**From:** Linero, Alvaro  
**Sent:** Friday, May 11, 2007 12:05 PM  
**To:** Sheplak, Scott; Nelson, Deborah  
**Subject:** FW: Okeechobee landfill - NSR rules  
**Attachments:** 0930104-012-AC-013-AV\_Okeechobee landfill \_RFI.doc

04-012-AC &amp; 0930104-013-AV

Re: Request for Additional Information ----- Construction & Title V Permit Application  
File No. 0930104-012-AC & 0930104-013-AV  
Okeechobee Landfill Inc., Okeechobee County

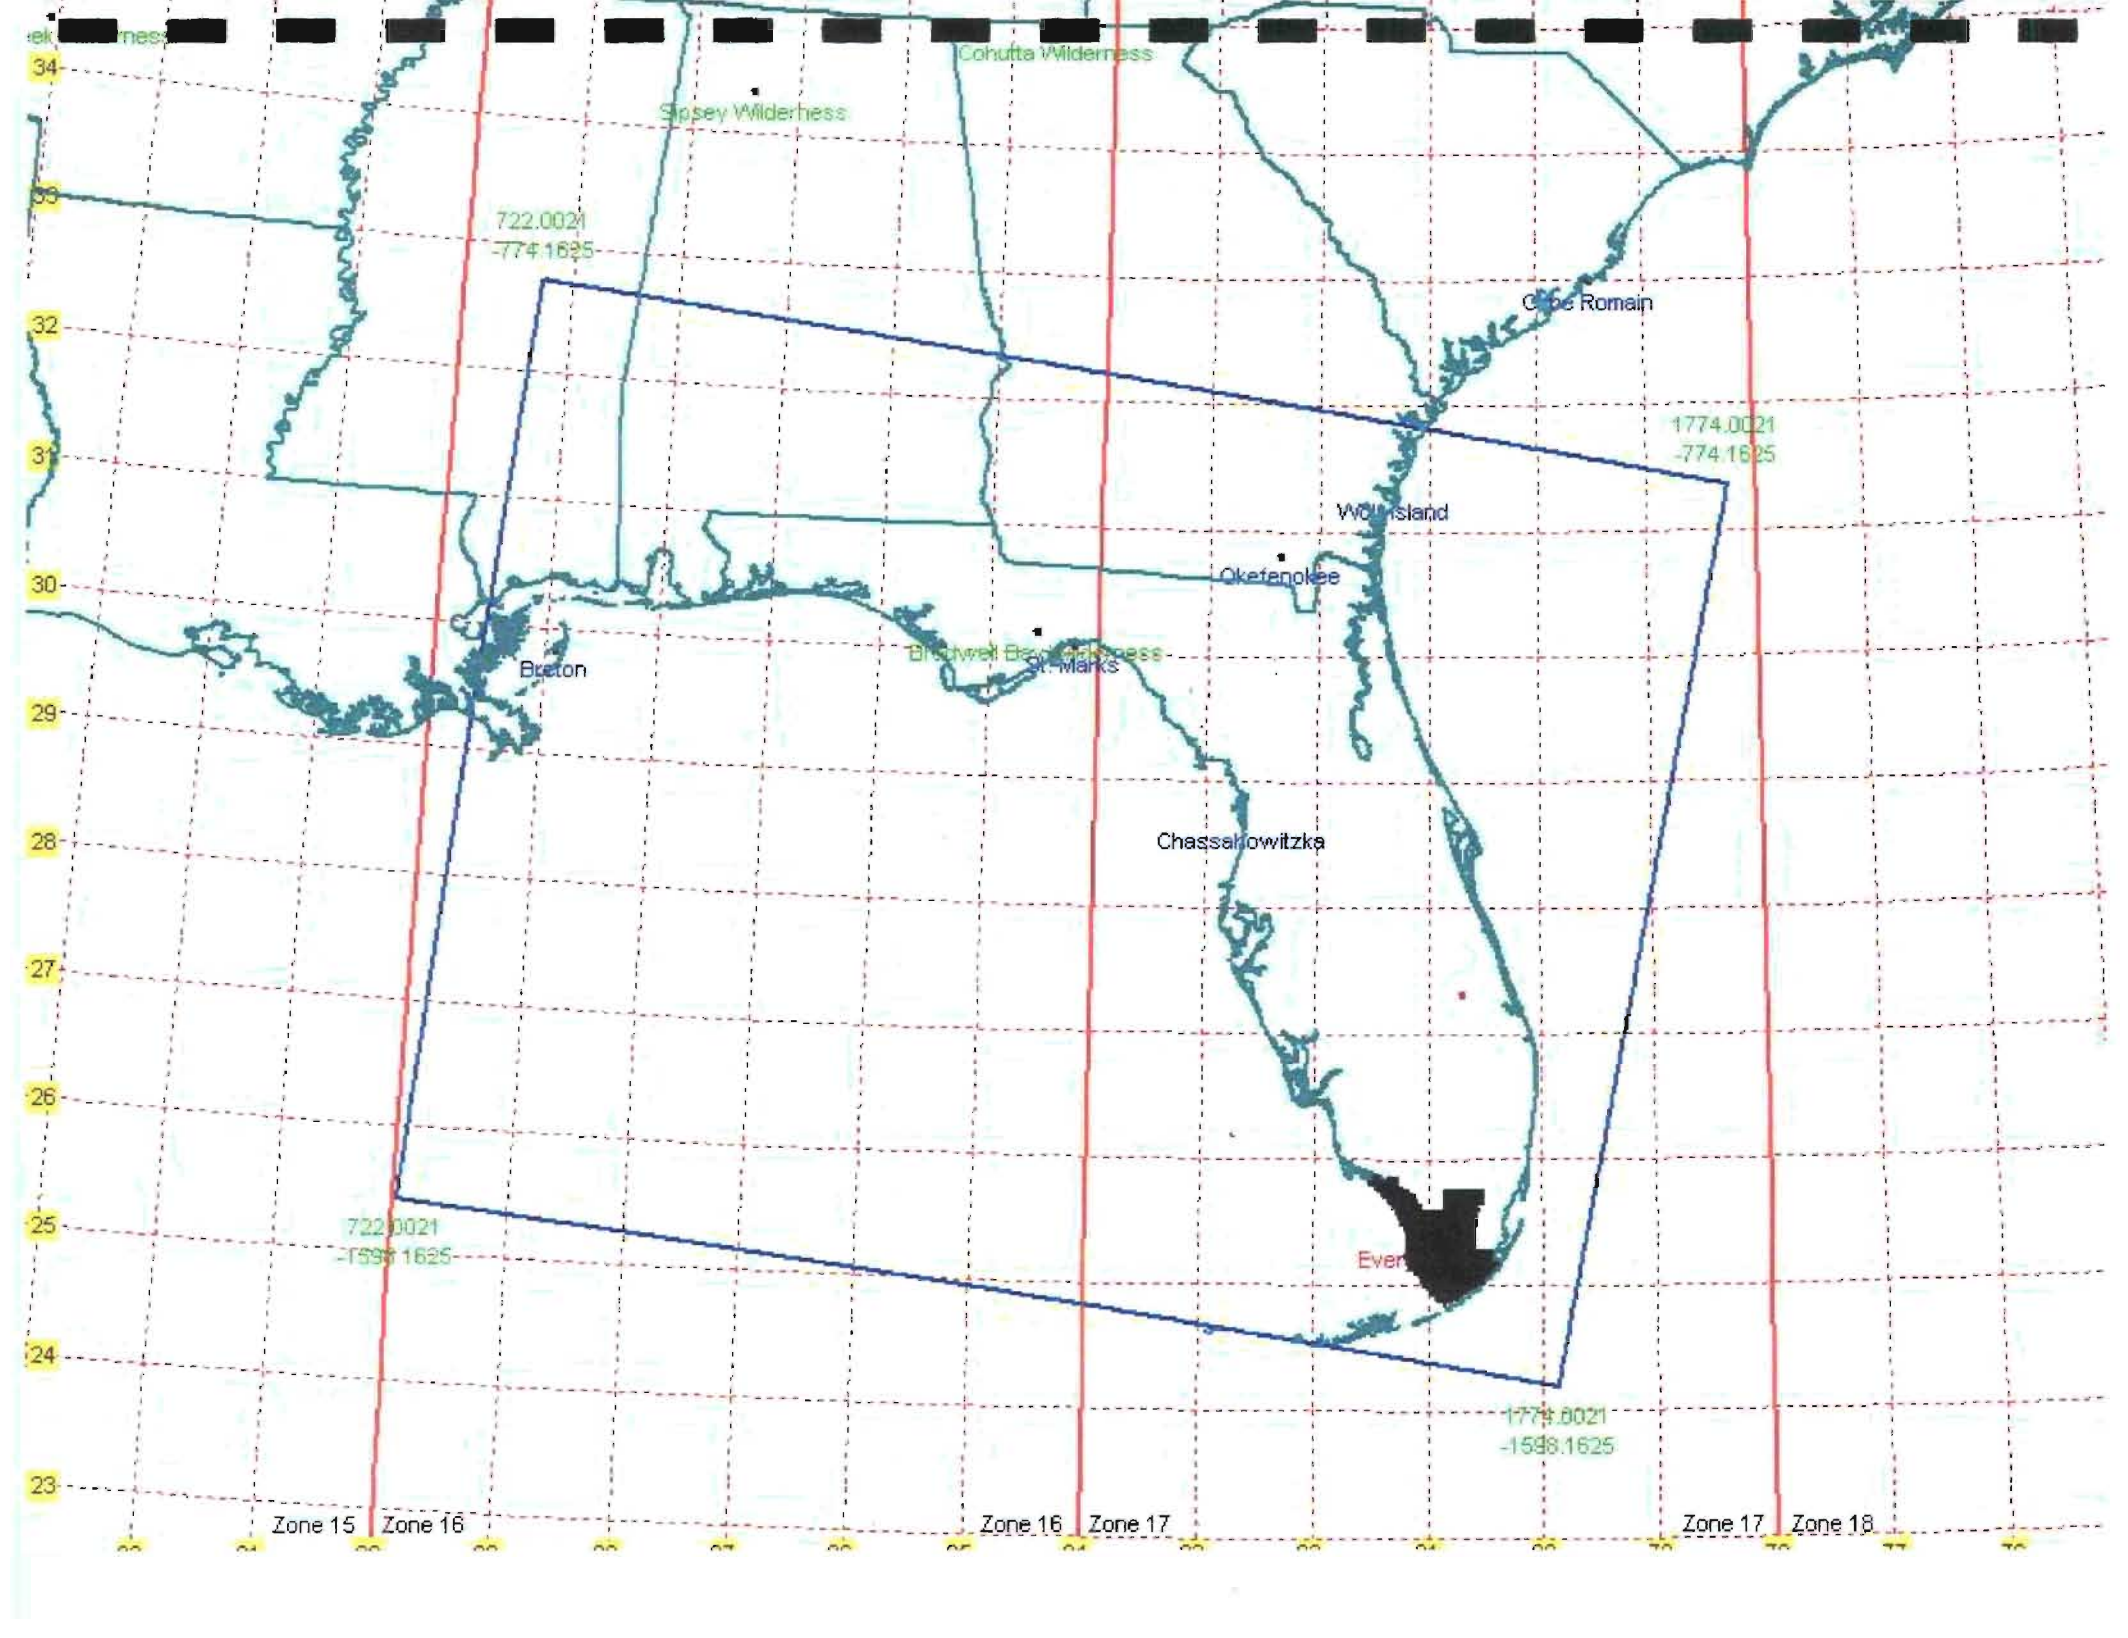
**Response:** The flares are shown in Figure 2-2 of the Air Quality Analysis report. They are represented in this figure as pink dots. The flares were placed in this location to represent the most conservative location, which shows the highest impacts. The flares may be placed anywhere in the area indicated on the plot plan (Figure 2-2) as the "Flares and Lo-Cat – 2 Acres" box.
